# Source Control Evaluation Work Plan, Revision 1

Baxter and Flaming  
3717 NW Saint Helens Road  
Portland, Oregon 97210

AEI Project No. 484441  
DEQ ECSI No. 6565

APPENDIX A  
Responses to Regulatory Agency Comments

**FIGURE 2**  
Project No. 484441

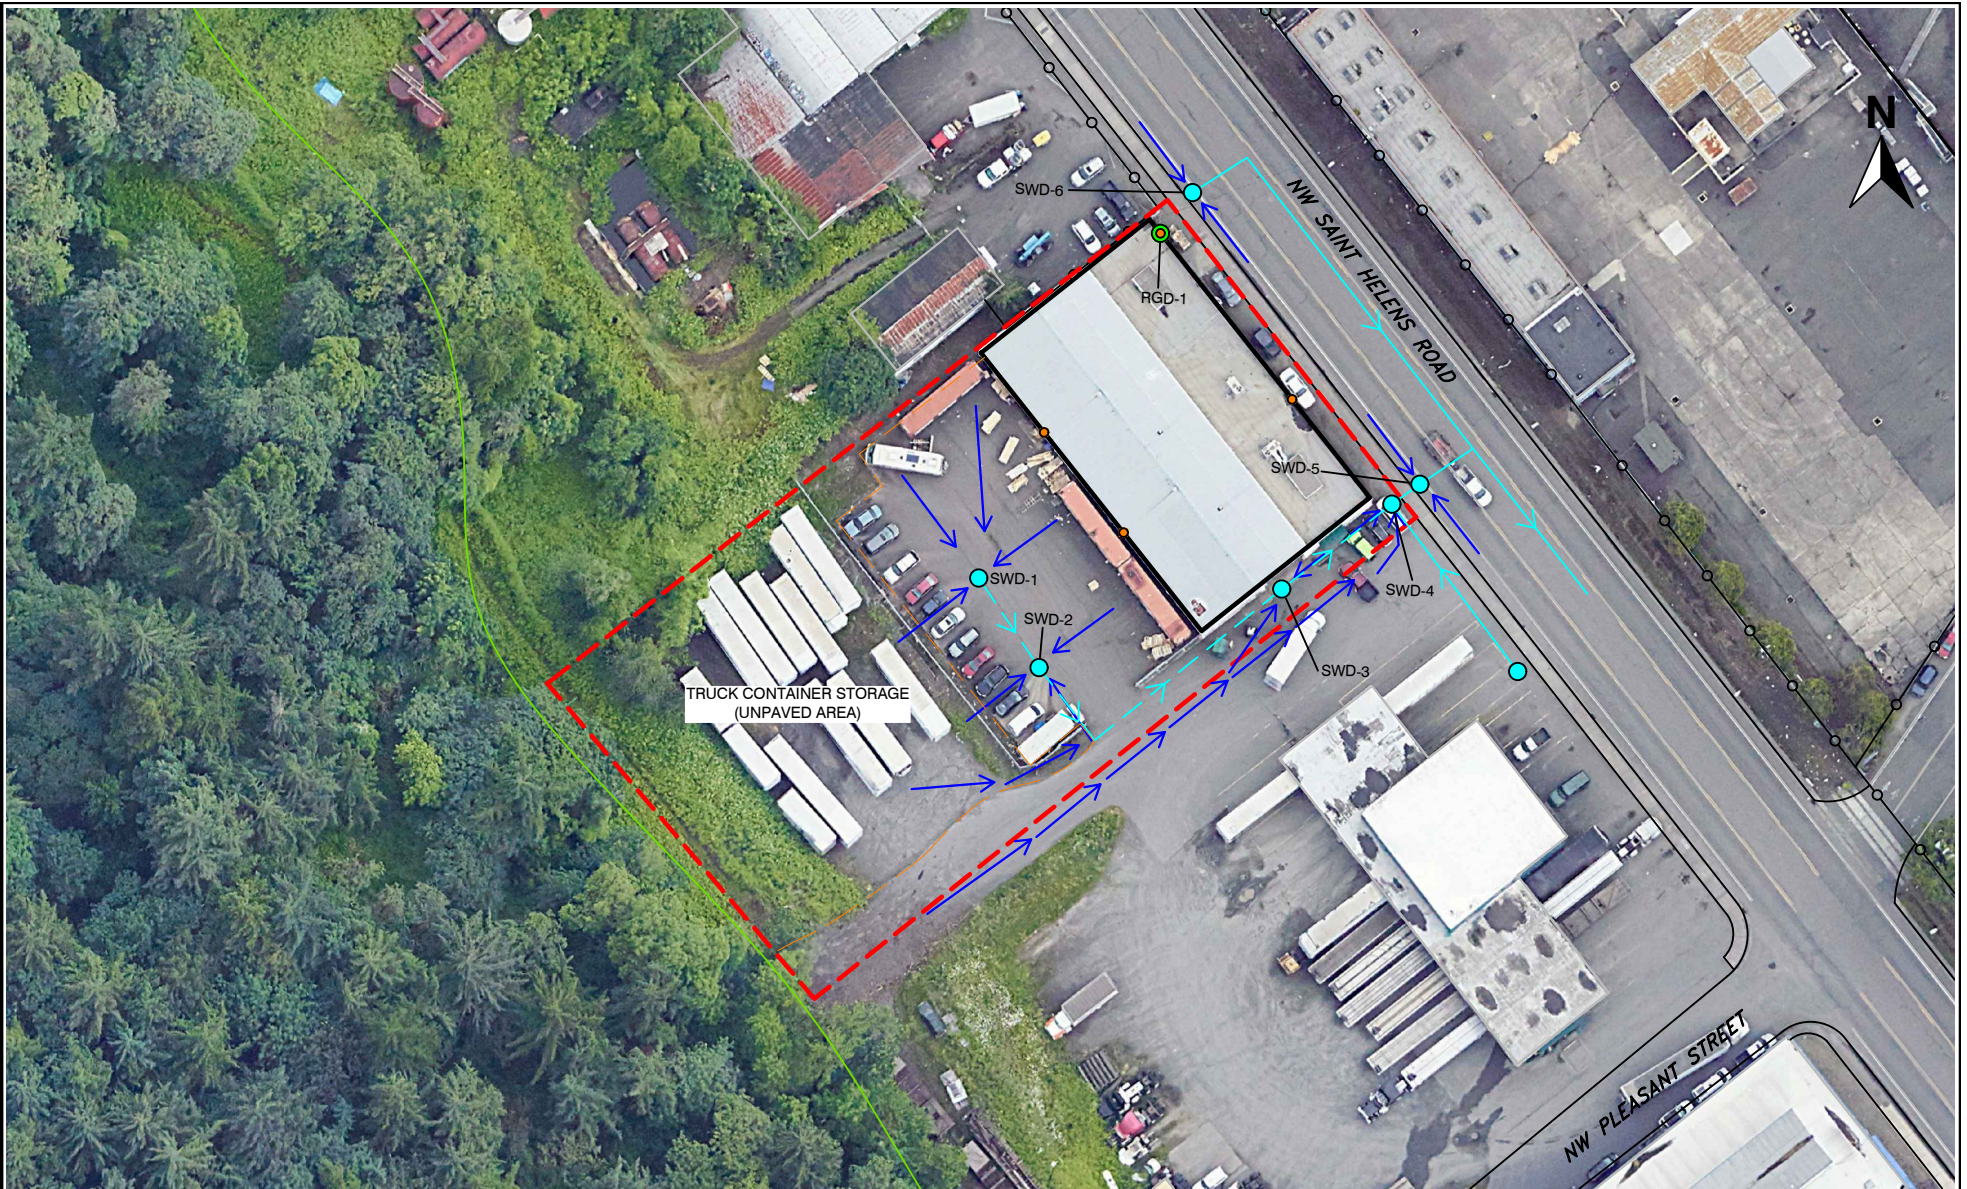
Comment 4: *All site operations and stormwater runoff should be evaluated as part of source control evaluations, regardless of who is conducting the operations at the site. Section 2.1 mentions that the truck storage is not associated with Baxter & Flaming; however, text should clarify that the stormwater from that portion of the site is still included in the proposed stormwater evaluation described in the Work Plan.*

**Response to Comment 4:** Stormwater from the truck container storage area flows to the same stormwater drains as the other portions of the Site (specifically, drains SWD-1 through SWD-4). The text of Section 2.1 has been revised to clarify this point, and Figure 3 has been revised to better indicate the various areas of the Site and apparent stormwater flow patterns.

**FIGURE 3**  
Project No. 484441

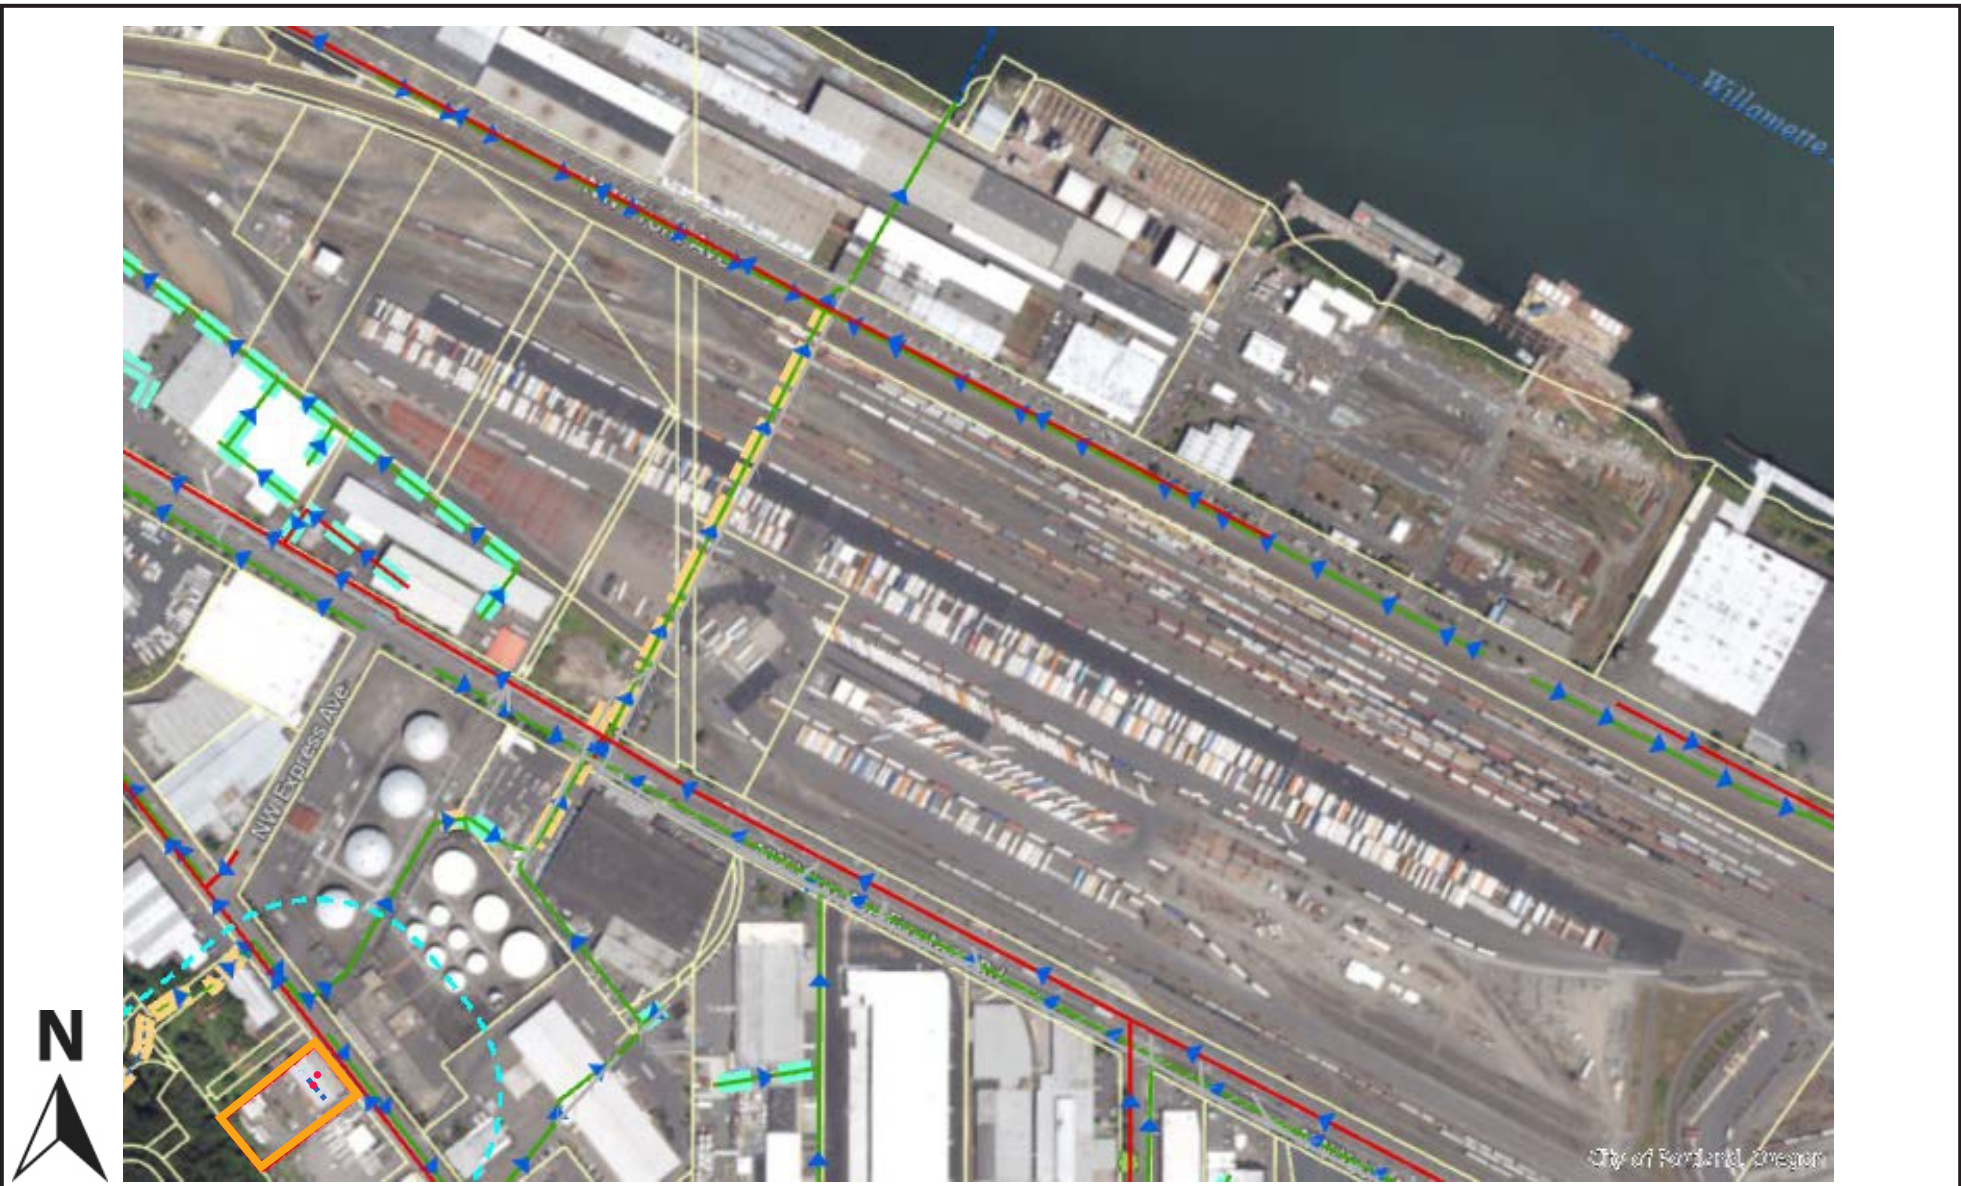
Comment 5: *If available, include information on the site stormwater conveyance system. The text and figures do not currently discuss the layout of stormwater piping.*

Comment 13: *Please provide a more detailed map for Figure 1 Site Drainage. Does drainage from SWD-1 and SWD-2 go to SED-4?*

**Response to Comment 5:** The Site Drainage Map (Figure 3) has been revised to depict the suspected alignment and flow direction of the storm drain lines. The configuration of the storm drain lines will be confirmed as part of site investigation activities proposed in the *Work Plan for Additional Subsurface Investigation, Revision 1*, prepared by AEI and dated December 16, 2024.

**Response to Comment 13:** The Site Drainage Map (Figure 3) has been revised to depict the suspected alignment of the storm drain lines and flow direction. See also the Response to Comment 5, above.
